Department of Energy

On October 7 and 8, 2010, the Defense Nuclear Facilities Safety Board (Board) conducted a public hearing on safety-related aspects of the design and construction of the Department of Energy's (DOE) Waste Treatment and Immobilization Plant (WTP) at the Hanford Site. Originally, the Board's Federal Register Notice announcing the public hearing stated that the record, associated with the public hearing, would remain open until November 7, 2010, for the receipt of additional materials. On November 1, 2010, via another Federal Register Notice, the Board extended the period of time for which the hearing record would remain open an additional 60 days until January 6, 2011.

Part 1: Panelist additions to the Public Record

SESSION 1: PRETREATMENT FACILITY MIXING SESSION (OCTOBER 7, 2010 AM)

Figure 3-4 Mass Fraction vs. Droplet Diameter for Sprays as a Function of Orifice Diameter and Upstream Pressure (Mishima, Schwendiman, and Ayer October 1978)

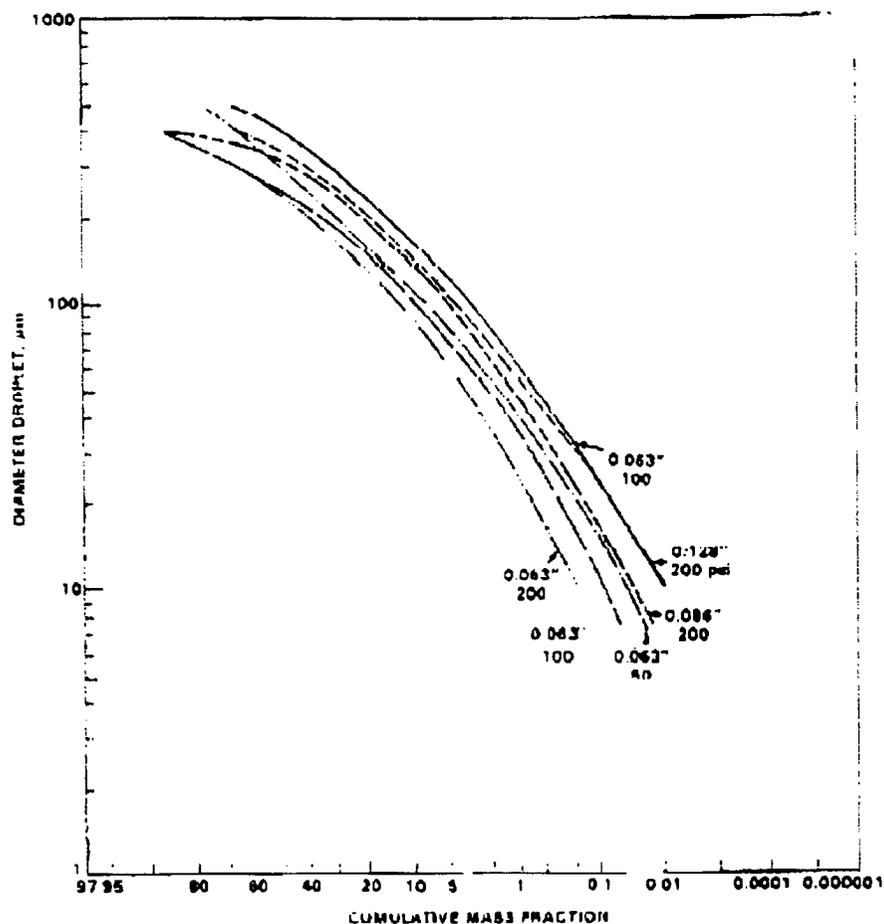
It is apparent from examination of Figure 3-4 on page 3-20 of the handbook that the bounding value of $1E-4$ [ARF][RF] does not bound all potential sprays from nozzles and therefore may not be bounding for metal vessels and piping. As illustrated in the figure and stated in the Handbook discussion, the size distribution of a spray formed by forcing liquid through a pressure nozzle/orifice becomes finer with decreasing size of the orifice and increasing pressure. The Handbook data and discussions were adopted from previous accident consequence studies for nonreactor nuclear facilities as discussed below.

- The Handbook recommended bounding [ARF][RF] of $1E-4$ of respirable droplets ($\leq 10\ \mu\text{m AED}$) is based on "the coarsest distribution generated by commercial spray nozzles shown in Figure 3-4." While the $1E-4$ value corresponds to discharge from a nozzle of 0.128" diameter and 200 psig, no specific recommendations regarding leak size and pressure was intended in the Handbook.
- The [ARF][RF] of $1E-4$ of respirable droplets was originally selected for the PNL/NRC evaluation of a seismic scenario in a specific facility, Babcock and Wilcox mixed oxide fuel fabrication, and was incorrectly labeled as a "spray release". The value is an estimate of the stable (post interaction and deposition) liquid aerosol in a glove-box based

- Figure 3-4 shows that the size distribution of a spray formed by forcing liquid through a pressure nozzle/orifice becomes finer with decreasing size of the orifice and increasing pressure.
